ADDENDUM NO. 3  
MAY 17, 2019

BID # 2248-19 Fire Alarm Renovations (Eastern Middle School)

**PROJECT**  
 GPS EASTERN MIDDLE SCHOOL  
 FIRE ALARM REPLACEMENT

**DRAWING TITLE**  
 FIRE ALARM BASEMENT & FIRST FLOOR PLANS  
 - NEW WORK

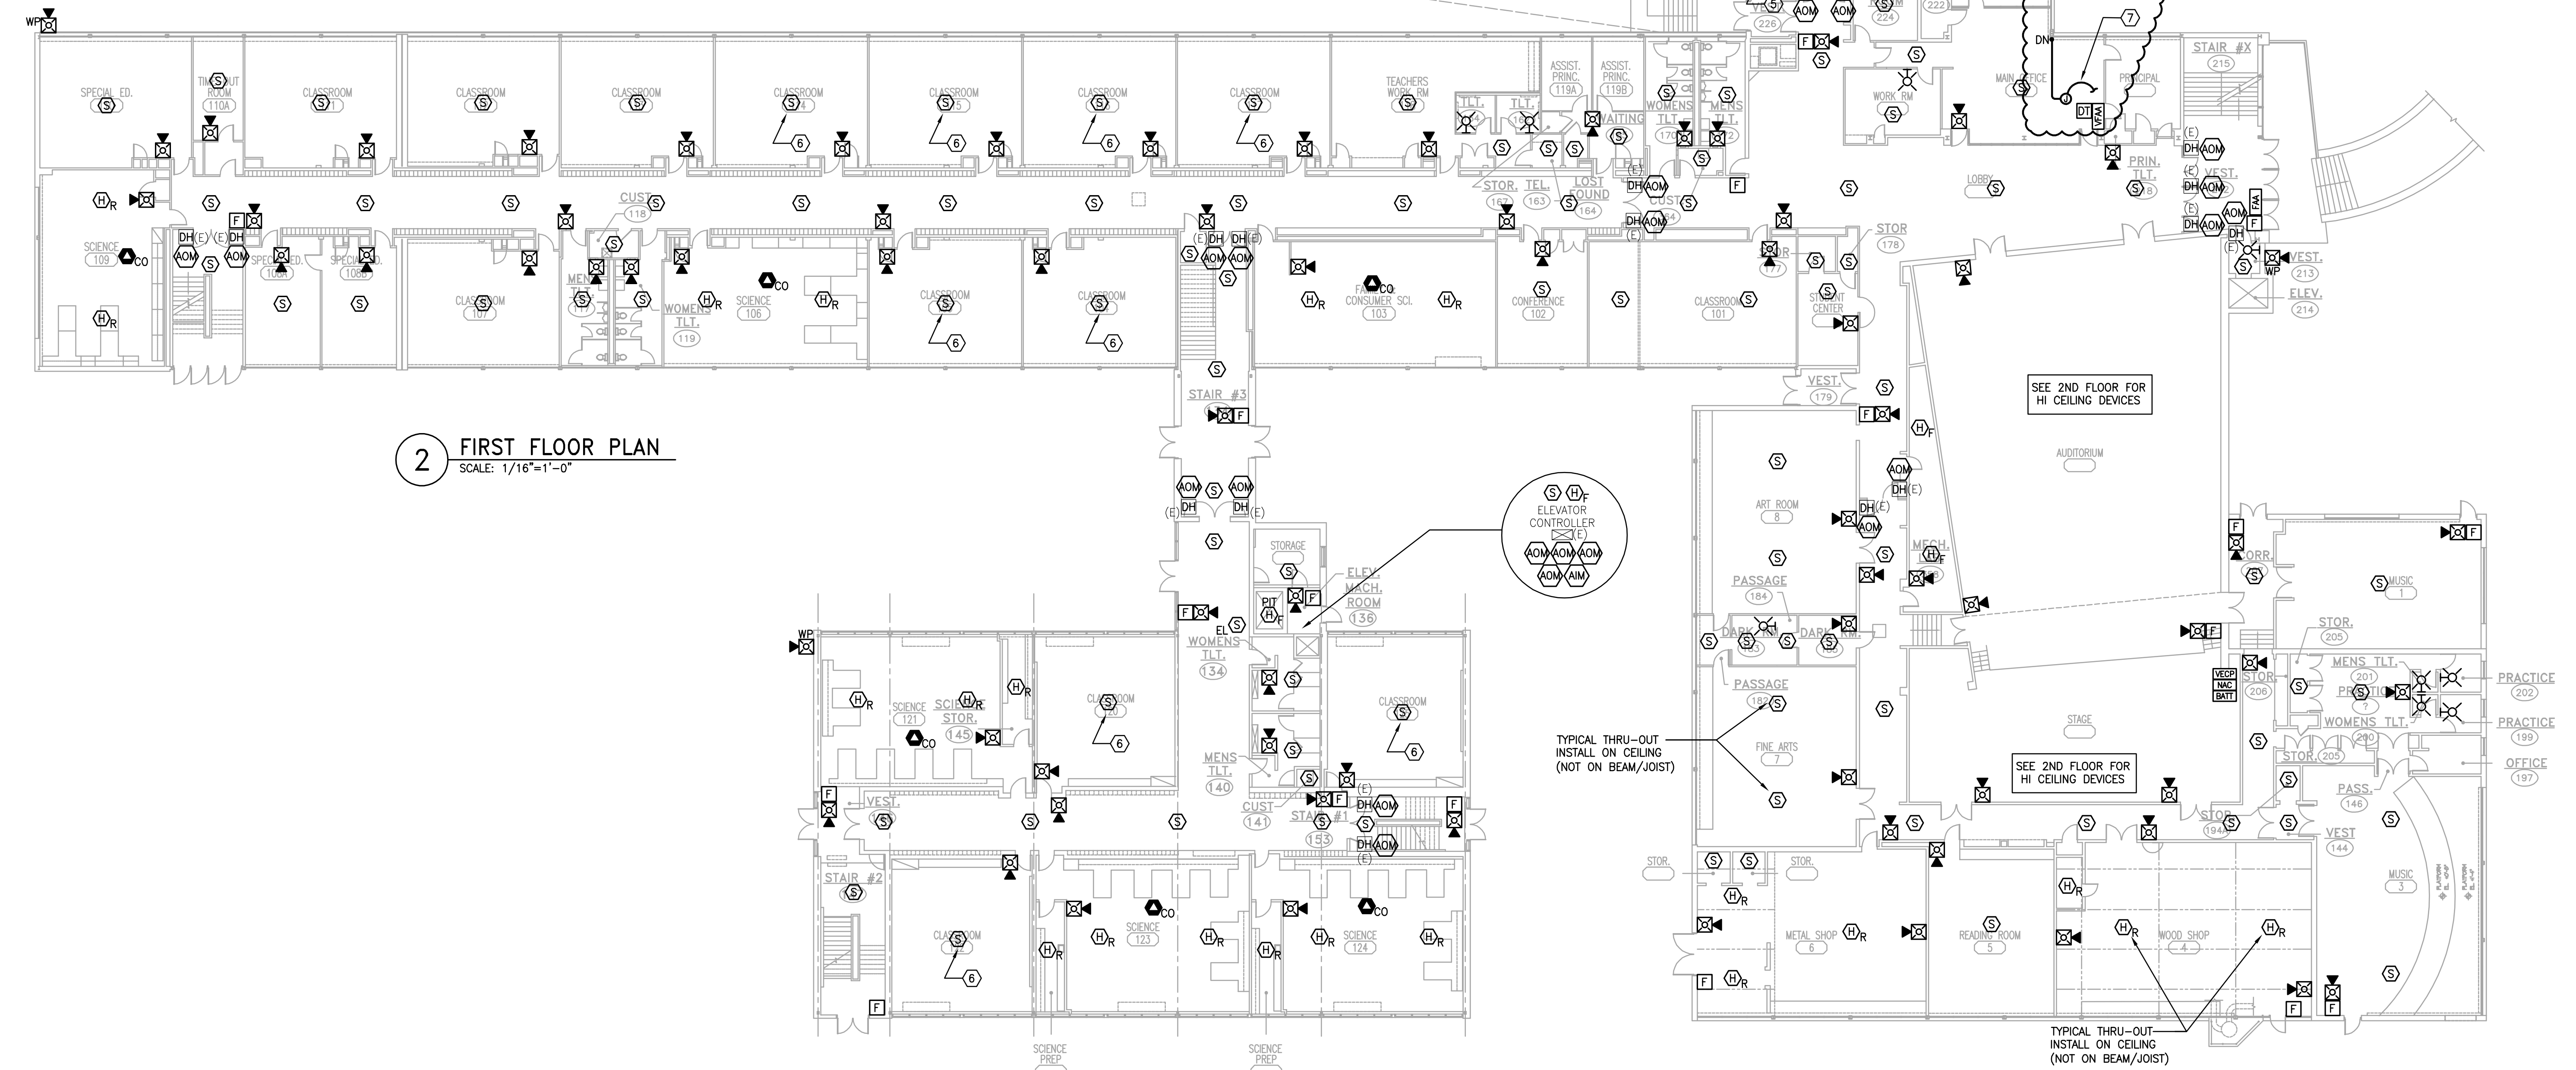
**Drawing FA-200**

1. Added Key Note-7 and associated wiring on plan between main office Alertus panel and basement FACP for integration of Alertus TTS (text-to-speech) function into FA System.

7. 1" WITH ALERTUS SYSTEM INTERFACE WIRING TO FA SYSTEM TERMINATE TO EXIST ALERTUS PANEL IN MAIN OFFICE AND TO FACP IN BASEMENT. PATHWAY SHOWN IS FOR REFERENCE ONLY. ACTUAL ROUTING SHALL BE BY CONTRACTOR AS APPROVED IN FIELD PRIOR TO WORK. REUSE OF EXIST CONDUIT IS PERMITTED WHERE AGREED IN GOOD CONDITION AND CODE COMPLIANT. REFER TO FA RISER FOR ADDITIONAL INFORMATION.

DRAWING TITLE  
**FIRE ALARM  
RISER DIAGRAM**

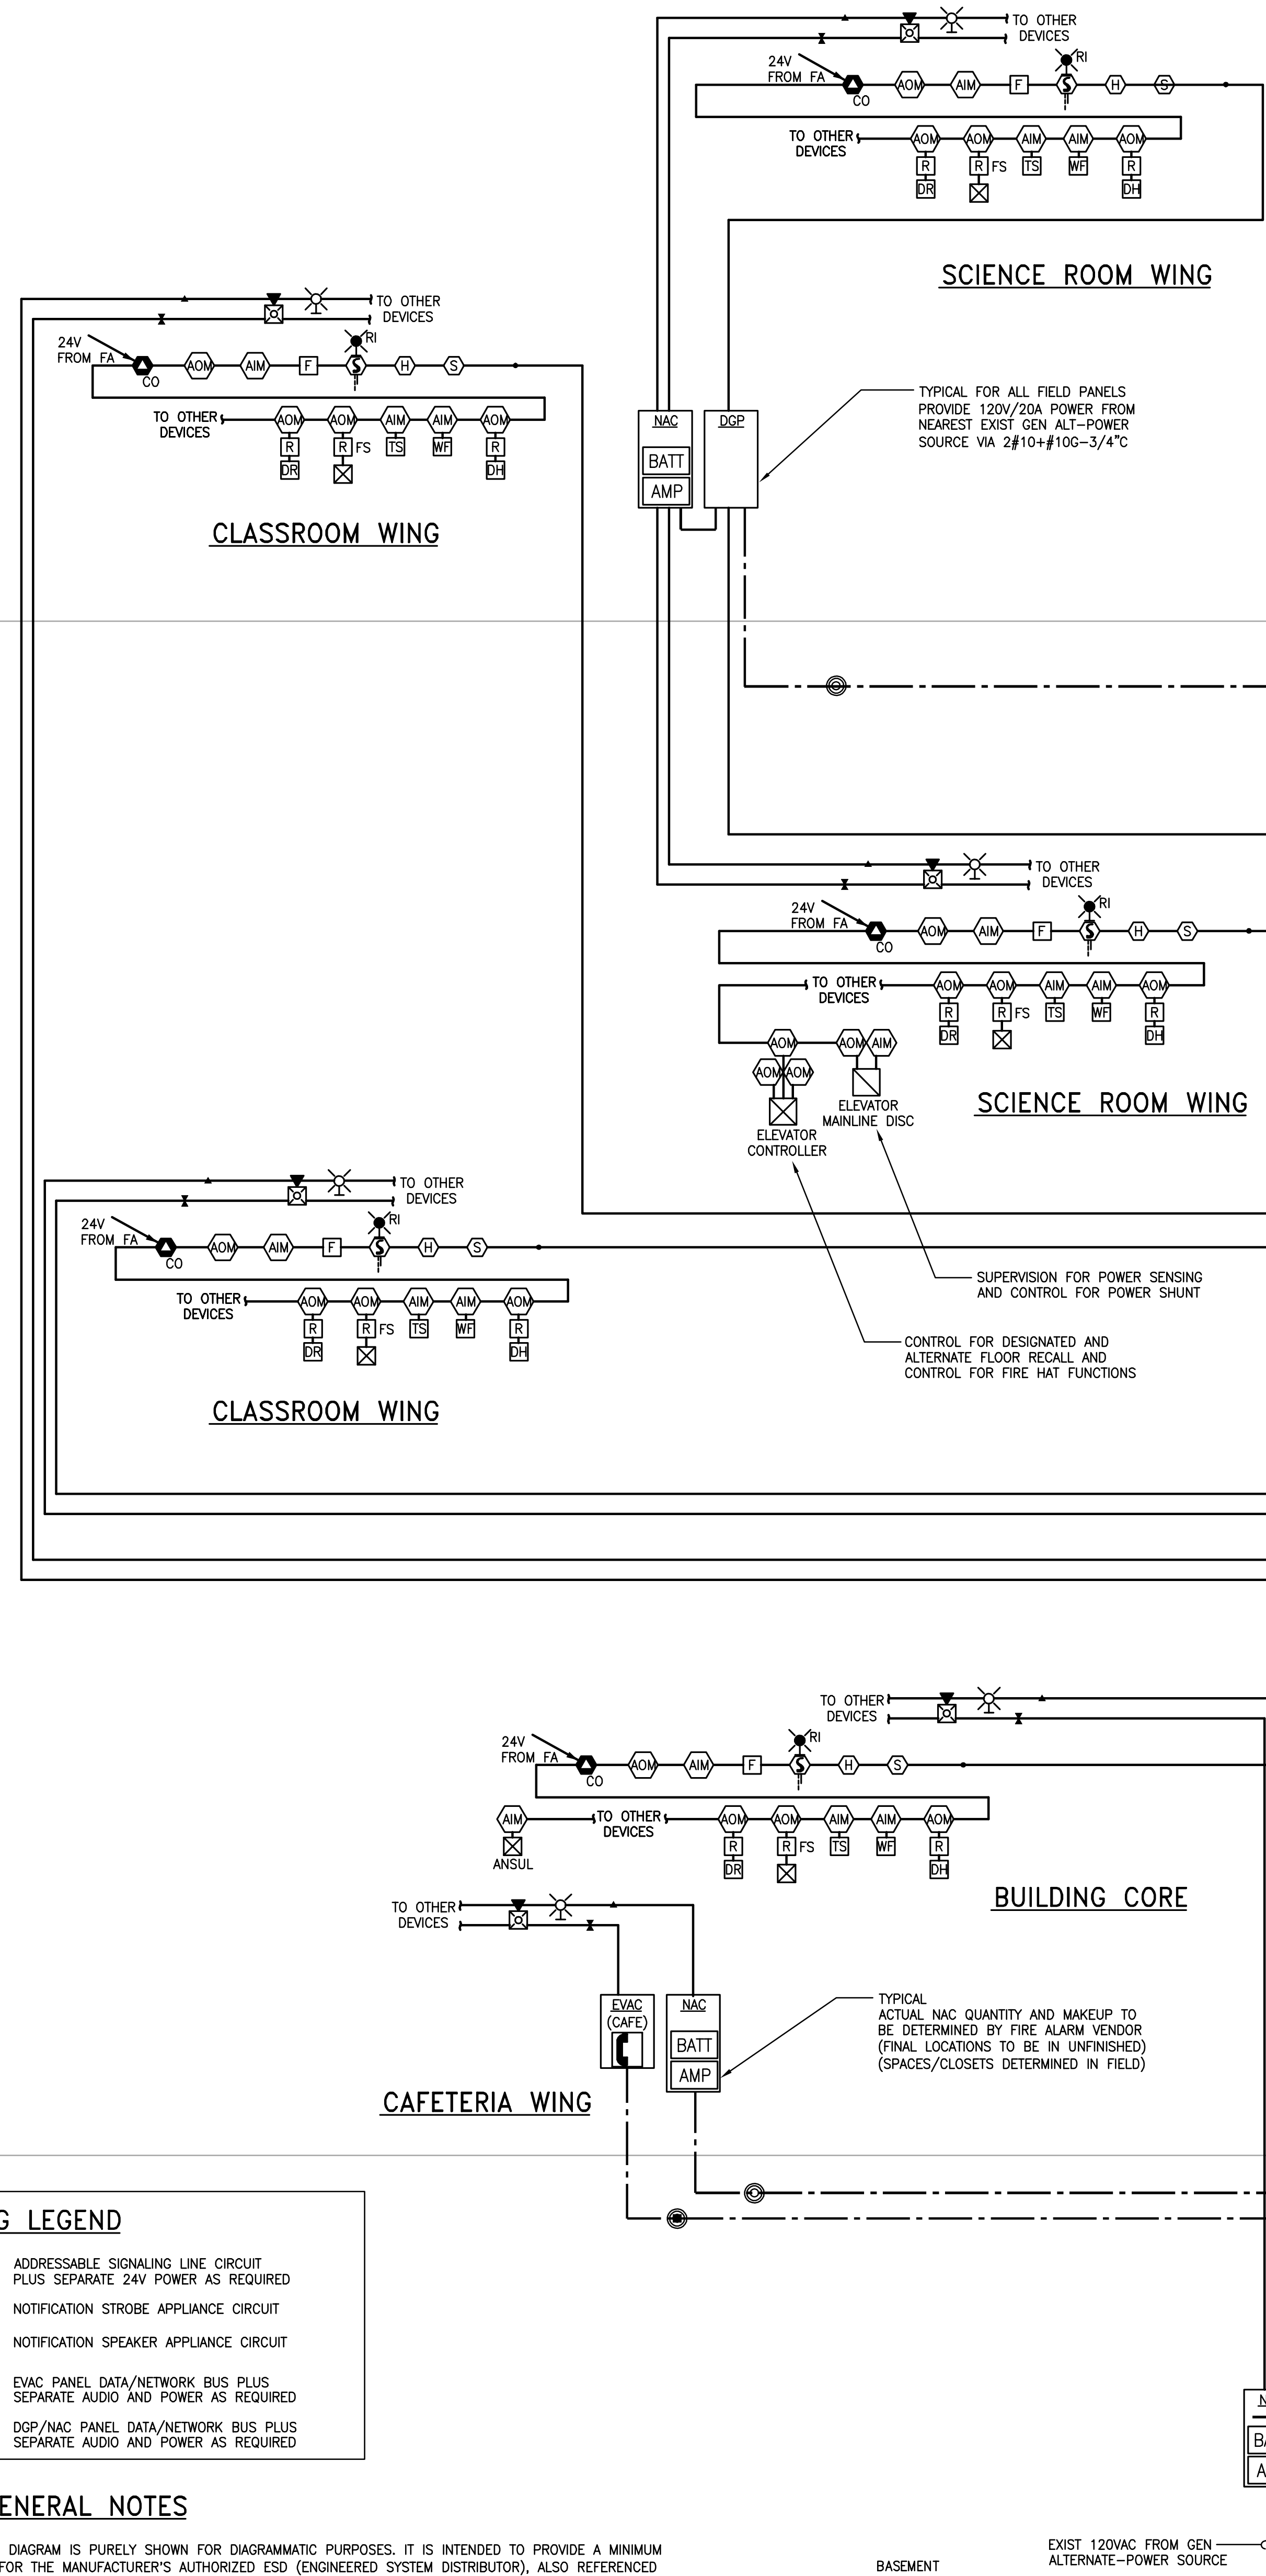
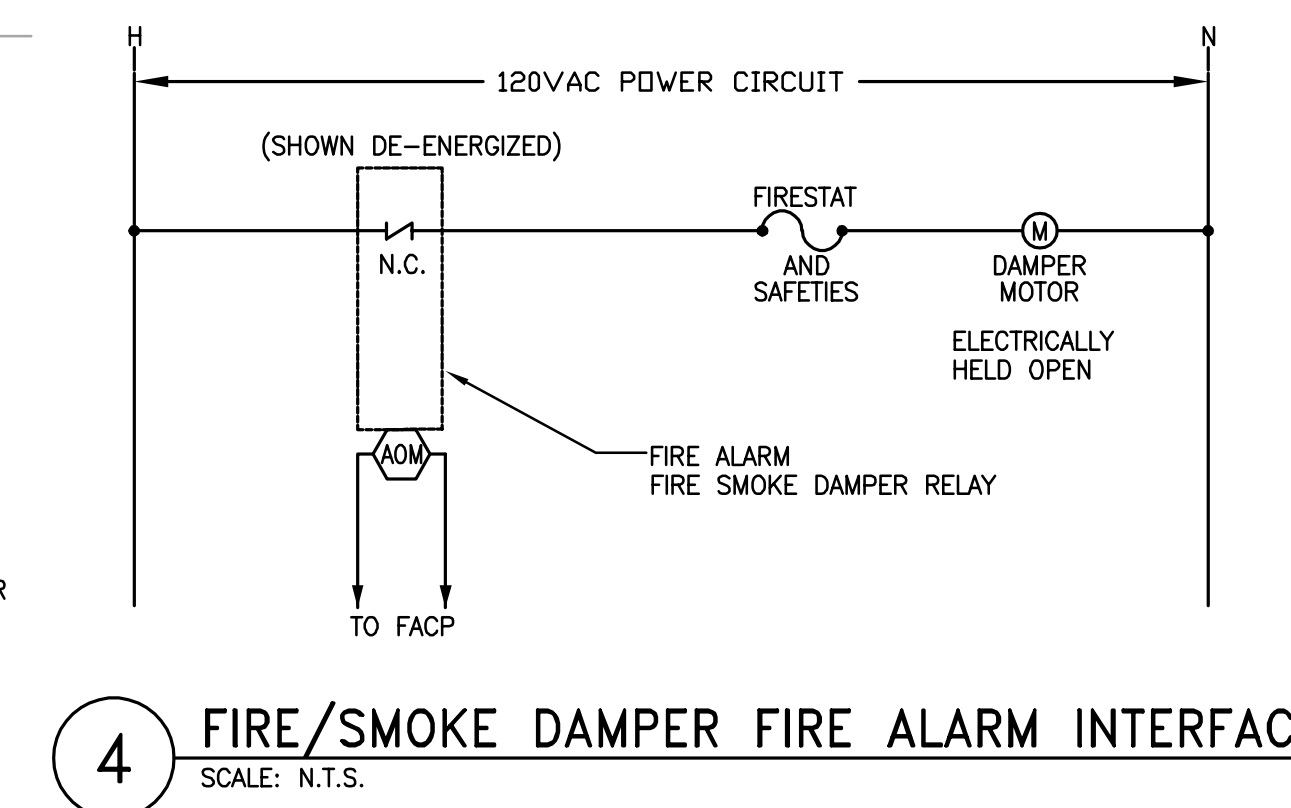
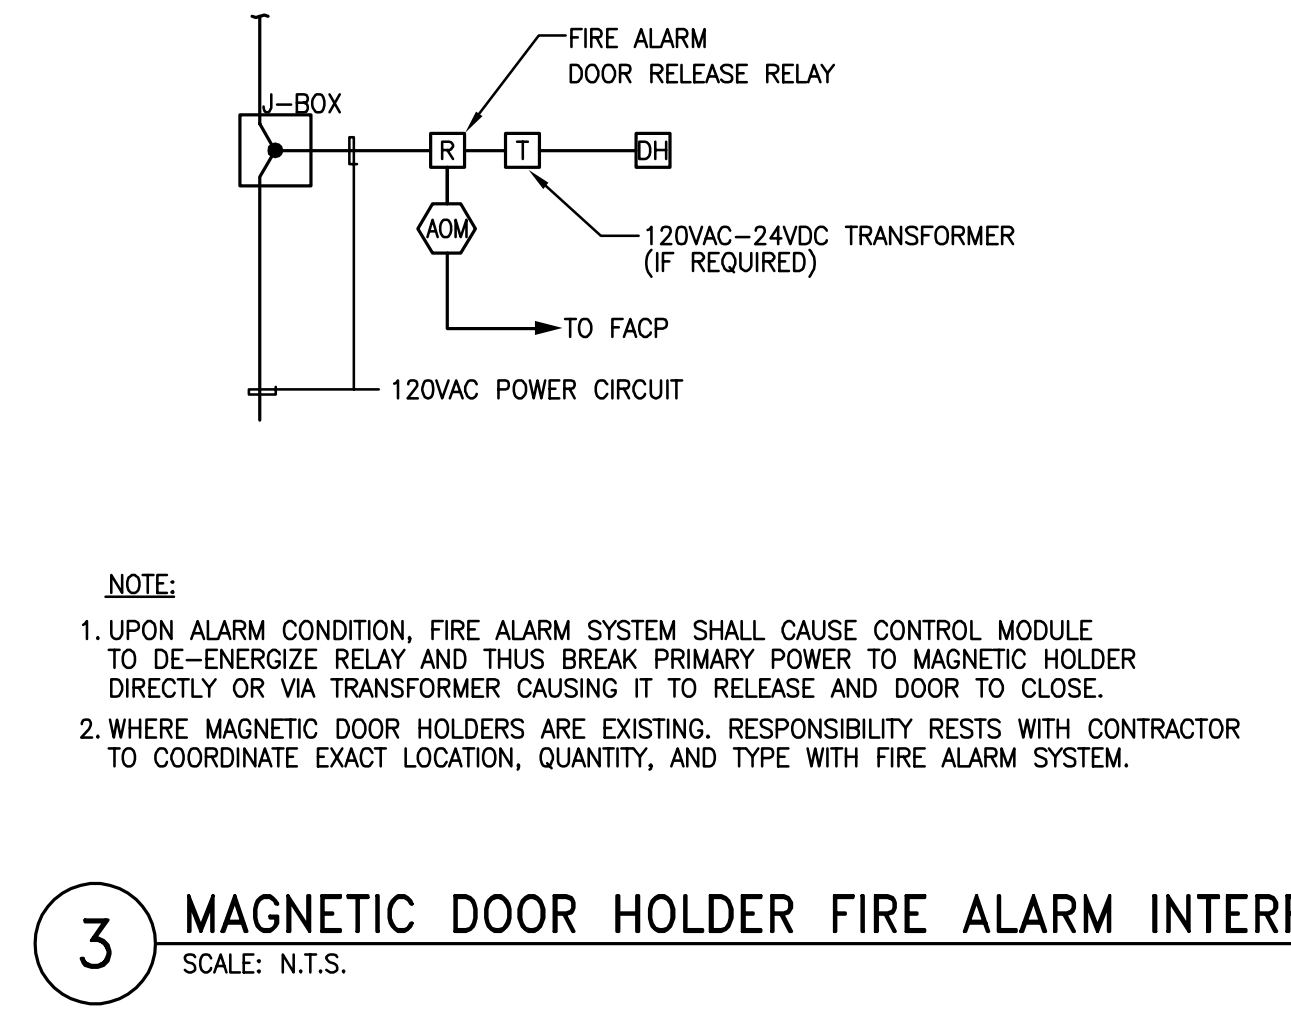
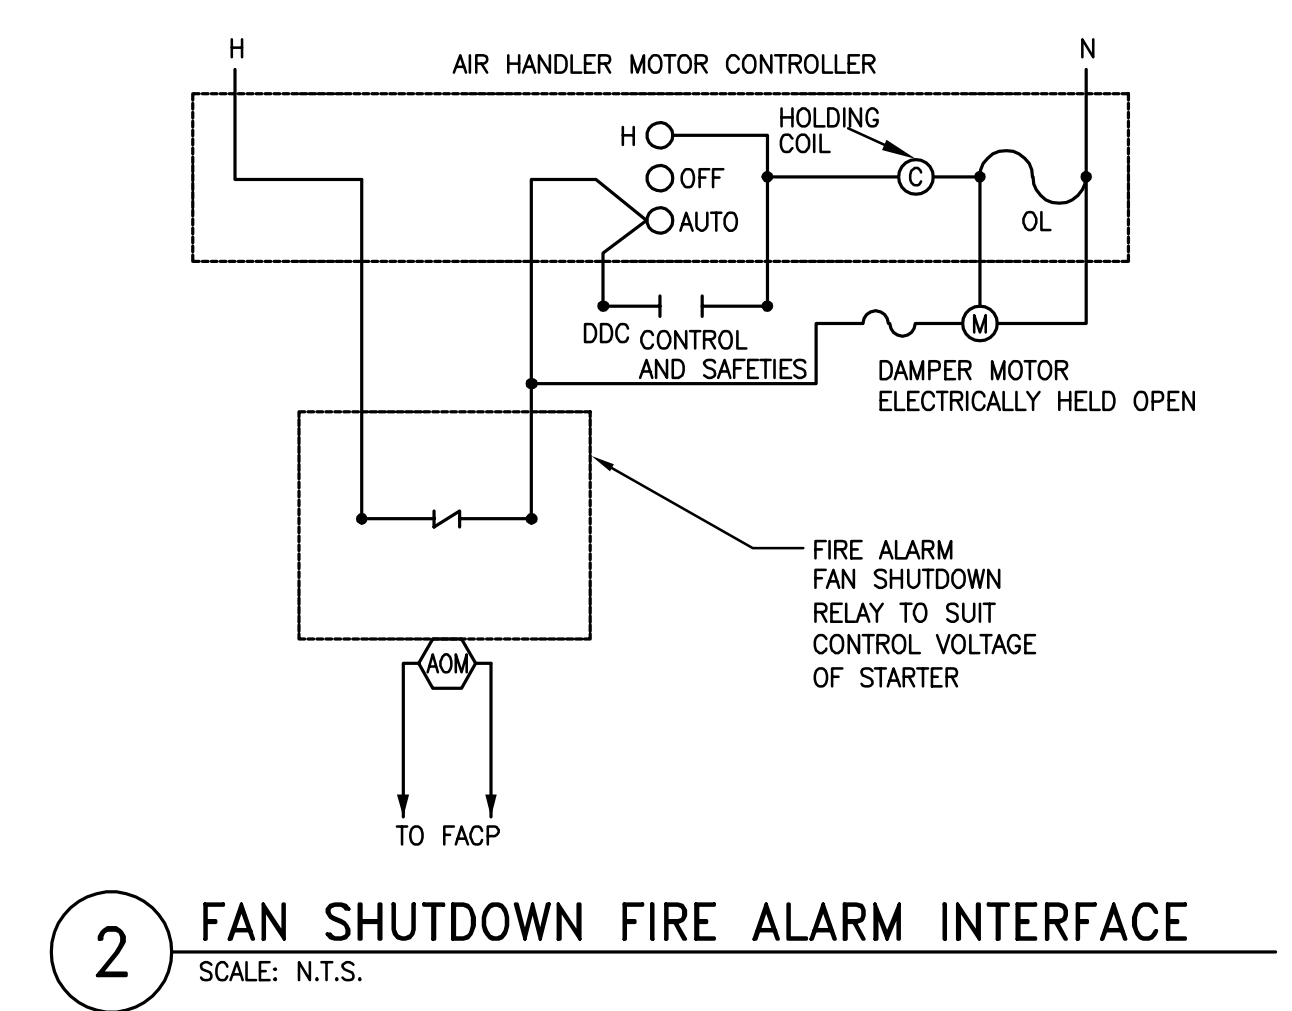
**Drawing FA-300**

1. Added Key Note-1 and associated work on riser describing the TTS integration scope, operation, and responsibilities by the Contractor.

**RISER KEY NOTES:**  
① PROVIDE A COMPLETE INTEGRATION OF THE TTS (TEXT-TO-SPEECH) FUNCTION FROM THE EXIST ALERTUS SYSTEM INTO THE UPGRADED FA SYSTEM. INCLUDE IN WORK ALL ASSOCIATED MODULES, COMPONENTS, WIRING, PROGRAMMING, AND THE LIKES. GENERAL OPERATION SHALL BE INITIATION OF ANY ALERTUS PANIC STATION WILL ACTIVATE A TTS PRE-MESSAGE BY ALERTUS FOR BROADCAST OVER ALL FA SPEAKER APPLIANCES TO ALERT STAFF LOCK-DOWN MODE IS IN EFFECT. THE SEQUENCE OF OPERATION PRIORITIES, RELATING TO FA OR ALERTUS, SHALL BE SETUP BY THE FA AUTHORIZED VENDOR/TECHNICIAN AS DIRECTED BY THE FIRE MARSHALL. INCLUDE COSTS TO COORDINATE ALL WORK WITH SAME AND THE GPS CONTRACTED INSTALLER OF THE ALERTUS SYSTEM FROM TIME OF SUBMITTALS TO TIME OF CLOSEOUT.
